Seventy-seventh session

Regulations Nos. 37 (Filament lamps), 99 (Gas discharge light sources), 128 (Light emitting diodes light sources) and the Consolidated Resolution on the common specification of light source categories

Proposal for Supplement 7 to the original version of Regulation No. 128 (Light emitting diodes light sources)

Submitted by the expert from the International Automotive Lighting and Light Signalling Expert Group (GTB)*

Figure 1

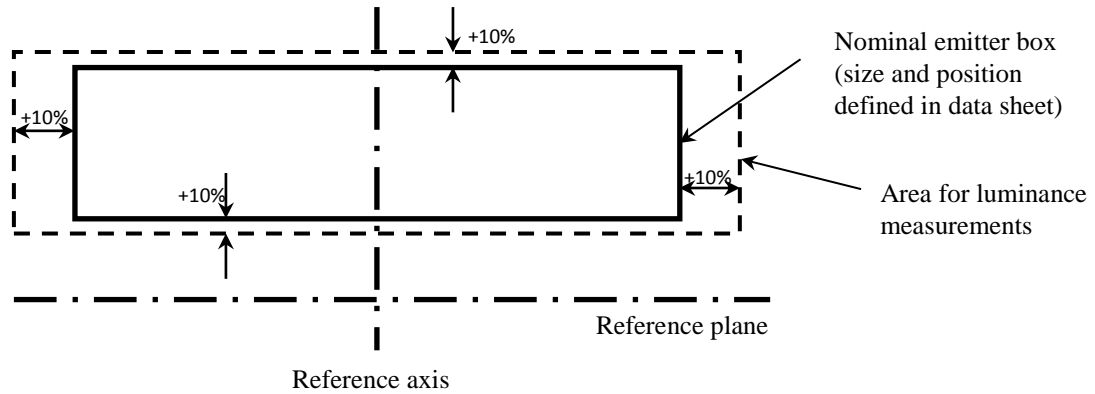
2. The luminance measurements of an area shall be done in an equidistant grid in both directions.
3. Zone 1a and zone 1b shall be determined from luminance measurements of an area which consists of the nominal emitter box as specified in the relevant data sheet of Annex 1 and enlarged to all sides by 10 per cent of the corresponding box dimension (see figure 1). The value L_{98} is the 98th percentile of all values of these luminance measurements.

Figure 2

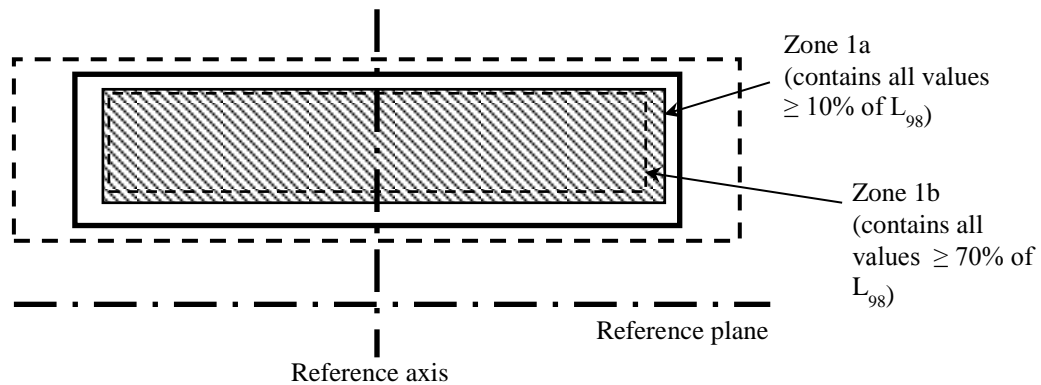
- 3.1. Zone 1a (light emitting area) shall be the smallest circumferential rectangle having the same orientation as the nominal emitter box and containing all luminance measurements with a value of 10 per cent or more of the value L_{98} . The value L_1 shall be the arithmetic average of the values of all luminance measurements in zone 1a (see figure 2). The value of $R_{0,1}$ shall be the surface ratio of zone 1a where the luminance value is exceeding 10 per cent of the value L_1 . The value of $R_{0,7}$ shall be the surface ratio of zone 1a where the luminance value is exceeding 70 per cent of the value L_1 .

- 3.2. Zone 1b shall be the smallest circumferential rectangle having the same orientation as the nominal emitter box and containing all luminance measurements with a value of 70 per cent or more of the value L_{98} .

Figure 3
Definition of zone 2

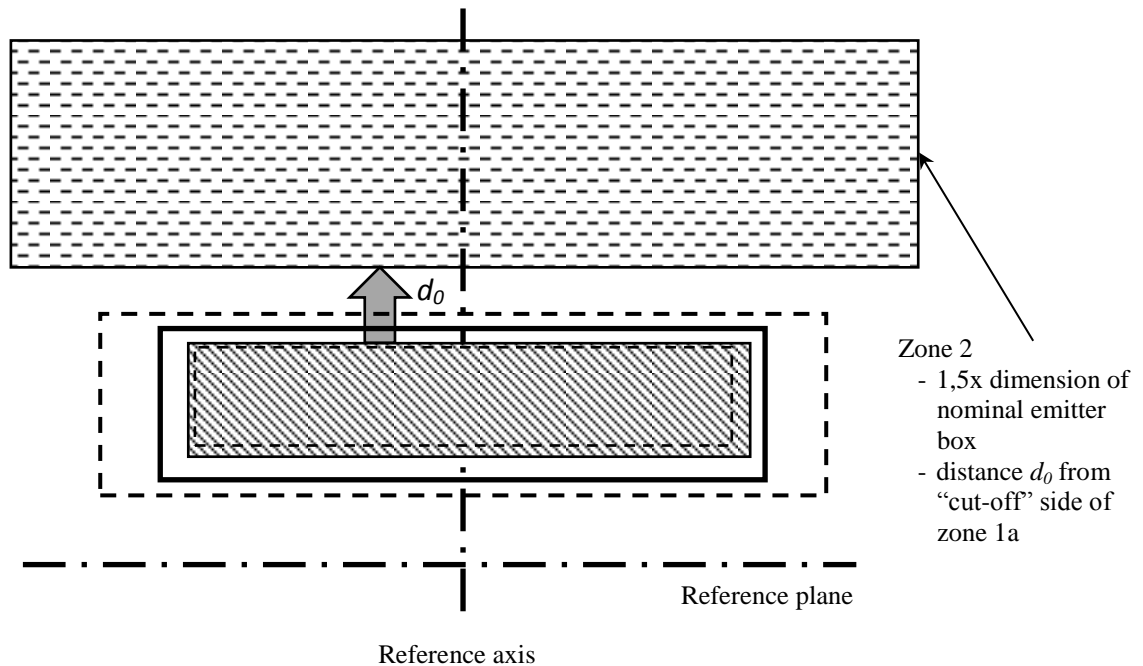
4. Zone 2 shall have in both directions 1,5 times the size of the nominal emitter box as specified in the relevant data sheet of Annex 1 and it shall be positioned symmetrically to the nominal emitter box at a distance of $d_0=0.2$ mm to zone 1a, unless otherwise specified on the data sheet (see figure 3). The value L_2 shall be the arithmetic average of 1 per cent of all measured luminance values in zone 2 which represent the highest values.
